SUBJECT: Triangle Expressway Southeast Extension (Complete 540) from NC 55 Bypass in Apex to US 64/264 (I-87) in Knightdale, Wake and Johnston Counties; Federal Aid No. STP-0540(19), STP-0540(20), and STP-0540(21); WBS Nos. 37673.1.TA1, 35516.1.TA1, and 35517.1.TA1; STIP Project Nos. R-2721, R-2828, and R-2829

From: [Alsmeyer, Eric C CIV USARMY CESAW \(USA\)](#)
To: [Ridings, Rob](#); [Thomson, Nicole J](#)
Cc: [Abi Sheffey](#); [Riffey, Deanna](#); [Matthews, Monte K CIV USARMY CESAW \(USA\)](#)
Subject: [External] RE: Complete 540, R2828, Modification 12 Request; Permit Site 41; DA# SAW-2009-02240
Date: Friday, August 4, 2023 12:52:31 PM
Attachments: [image001.png](#)
[230803_Site 41 Mod drawings_R-2828_Complete540_Wake.pdf](#)

**North Carolina Division of Water Resources
Transportation Permitting Unit
In-Field Minor 401 Water Quality Certification Modification**

Project Name/ TIP Project No.: R-2828; NC Hwy 540 Date: August 4, 2023

REVISIONS

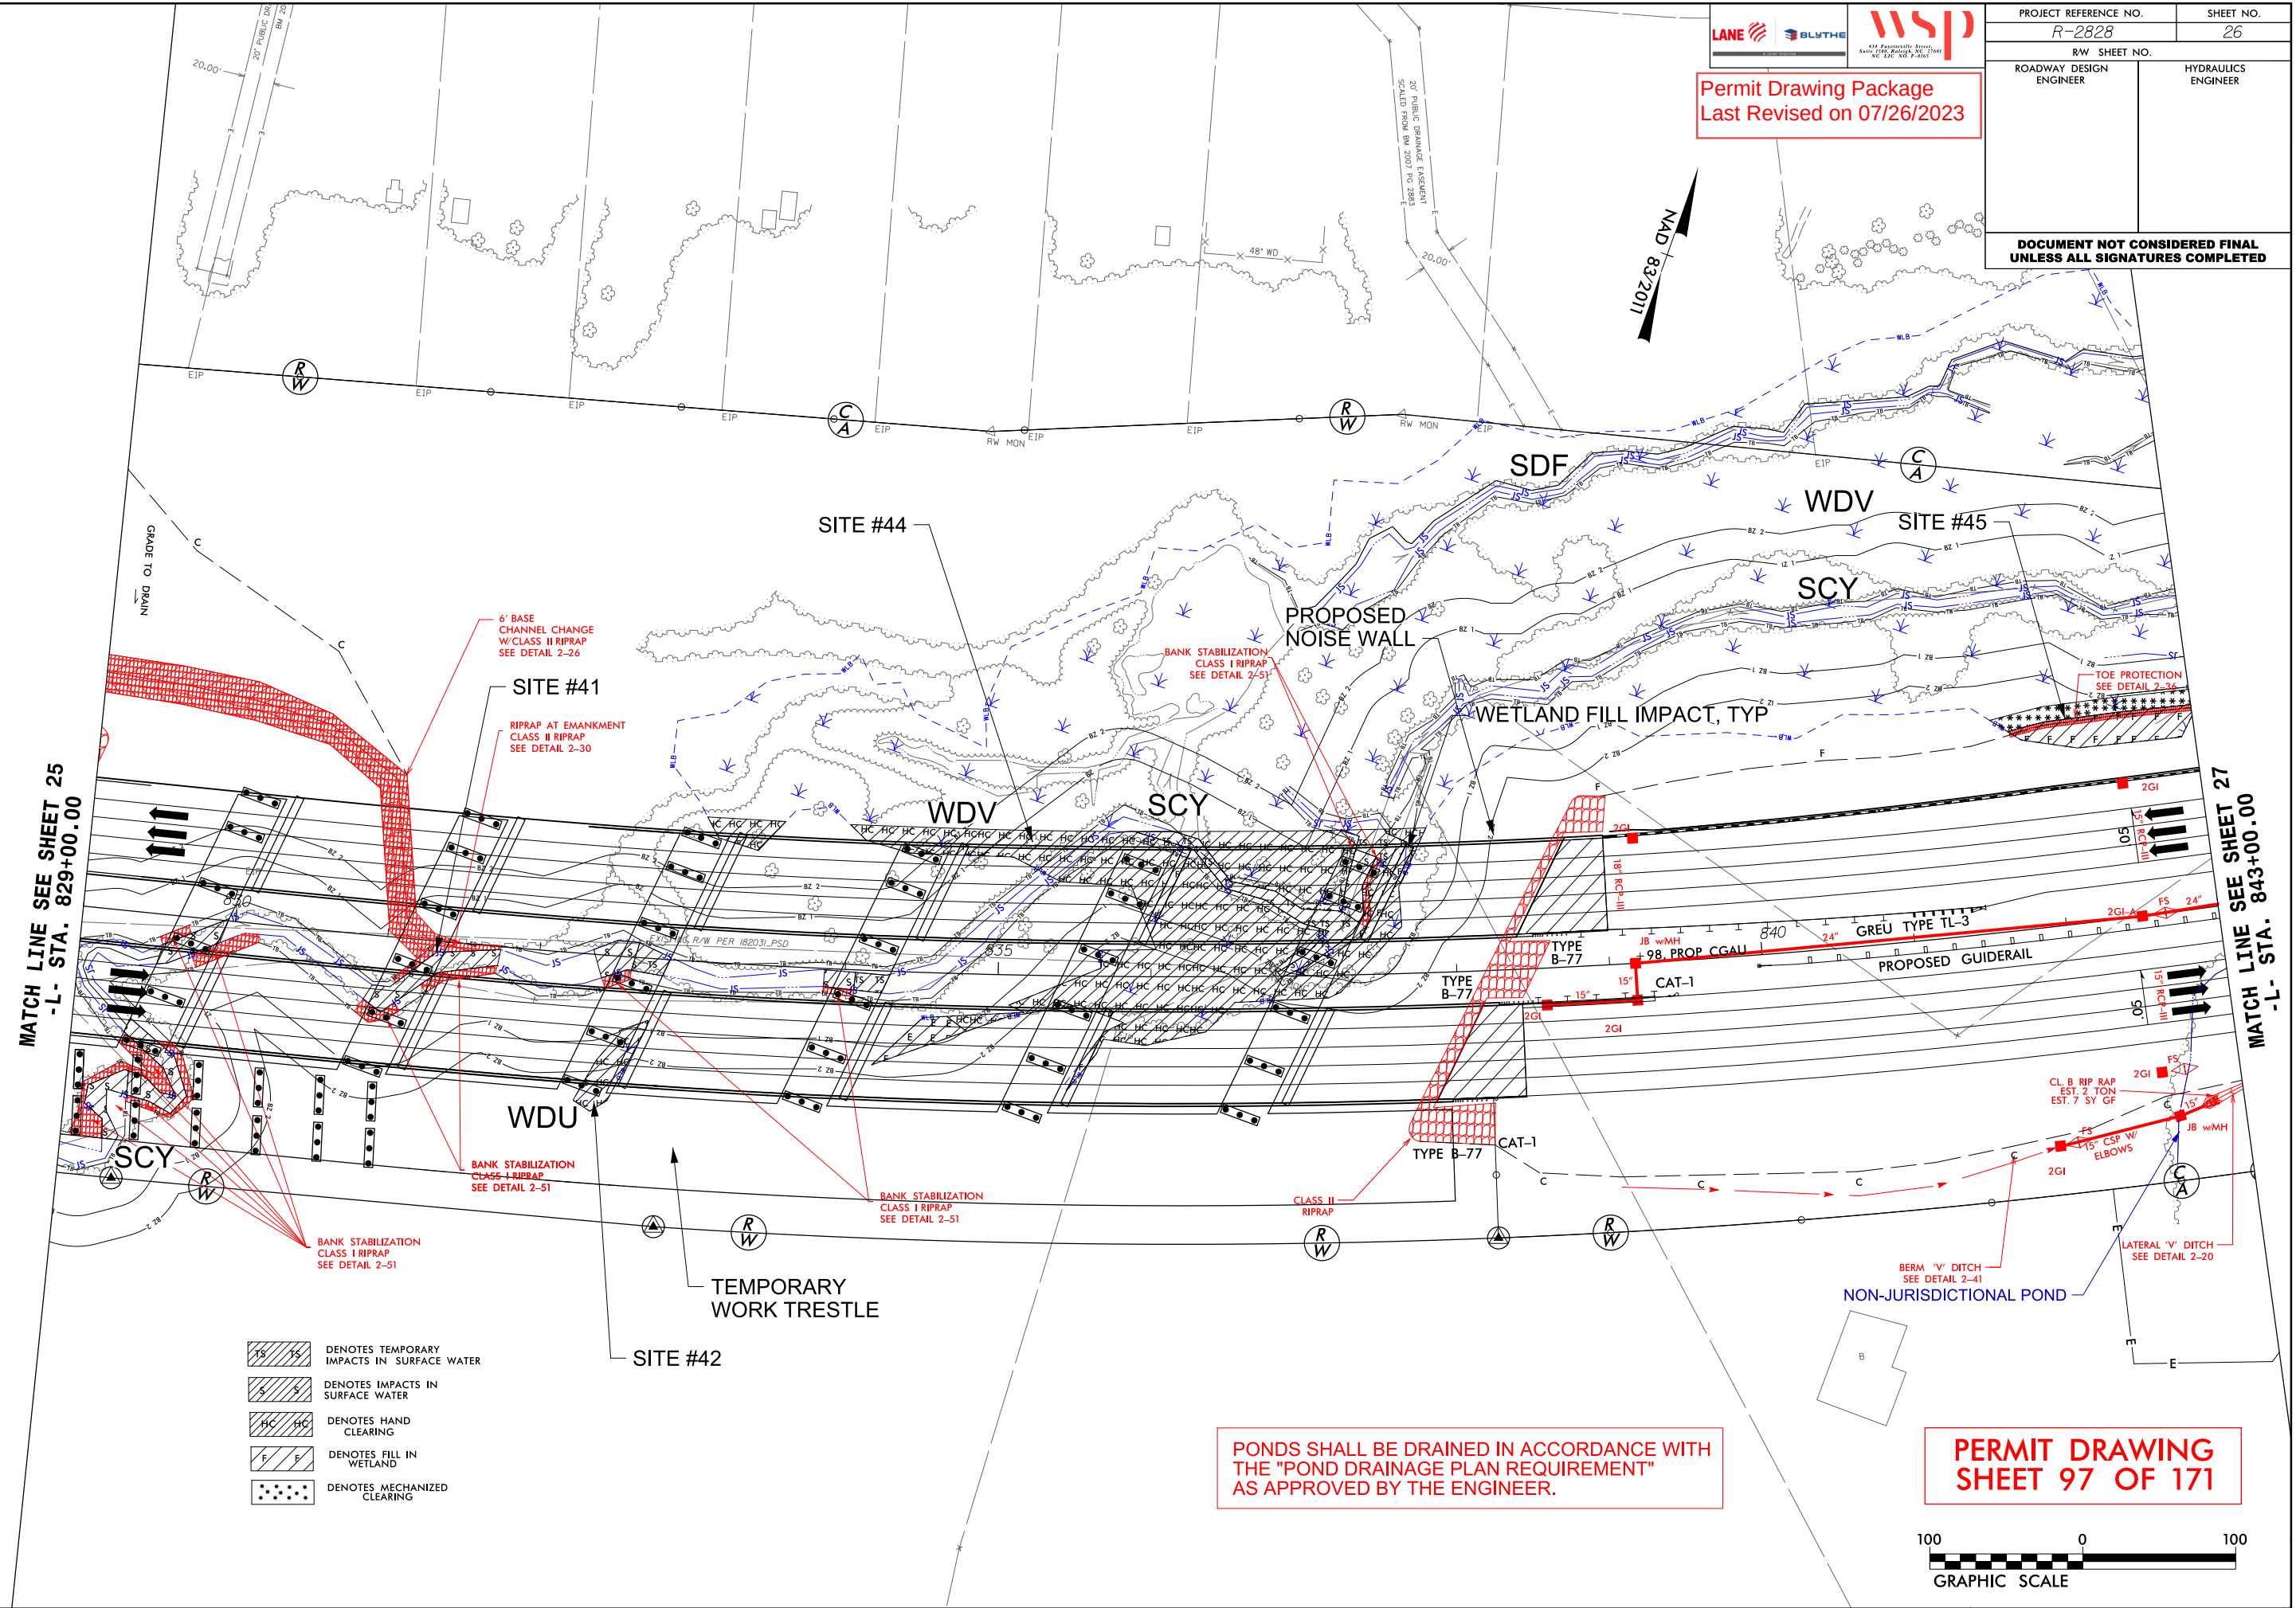
On August 3, 2023, the U.S. Army Corps of Engineers (Corps) received a request from NCDOT to modify the standard permit for the R-2828 project (Mod12), to adjust Impacts at Permit Site 41, Bridge Structure 9. The temporary work trestle bridge at Permit Site 41 was recently removed and some of the bank stabilization originally called for and permitted at this site was determined to not be needed. Another bank location at the site was originally permitted for only temporary impacts, but now requires permanent bank stabilization. There was significant scour at this bank location revealed after the temporary work structure has been removed, some of which was influenced by beaver activity in the area. Riprap for stabilization will not be placed in the thalweg of the channel.

- Limited area of bank stabilization:
 - Increase of 57 linear feet, 0.01 acre, of bank stabilization.
- Reduction of temporary stream impacts:
 - Decrease of 57 linear feet, 0.016 acre of temporary stream impacts

You were previously made aware of adjustments to Permit Site 41 at Bridge Structure 9. The temporary work trestle bridge was recently removed and per an earlier agency review, some of the bank stabilization originally called for and permitted at this Permit Site were ultimately determined to not be needed (concurred upon by both of you during the agency site walkthrough). Now there is a bank location originally permitted for temporary impacts that the JV wishes to convert to permanent bank stabilization. There was significant scour realized at this bank location now that the temporary work structure has been removed, some of which was influenced by beaver activity in the area. The attached permit drawings clearly identify the bank stabilization locations which were not installed and the new location where it is needed.

- Limited area of bank stabilization:
 - Increase of 0.01 acre of bank stabilization.
 - Increase of 57 linear feet of bank stabilization.
- Reduction of temporary stream impacts:
 - Decrease of 0.016 acre of temporary stream impacts
 - Decrease of 57 linear feet of temporary stream impacts

The Corps has completed the evaluation of your request and has determined that it is appropriate and reasonable, and that no public notice is required for this modification. Therefore, the permit is modified as requested and as shown on the attached drawings. No additional compensatory mitigation is required.
